AE 6190 HD-X Umrüstanleitung AM auf 4 Watt Modification Note to AM 4 Watt

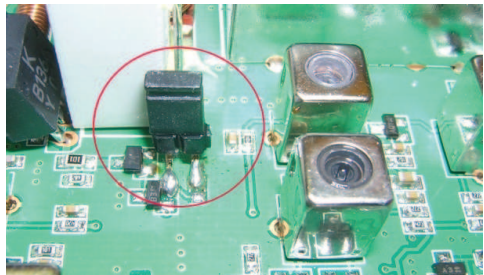
The country settings for Poland (**Po**), Italy and Spain (**E**) allow already 4 Watt AM, while the present standard for **dE** (80 CH FM/ 40 CH AM) and **EU** (40 CH FM/ 40 CH AM) require still 1 W AM. To change the AM outout in **dE** and **EU** settings to 4 Watts (as soon as allowed) open the cabinet on speaker side and close the jumper as illustrated.

Brücke offen oder einseitig gesteckt für 1 W
Jumper open or plugged with 1 pin for 1 W

Brücke geschlossen (kompl.gesteckt) für 4 W
Jumper closed (compl. plugged) for 4 W
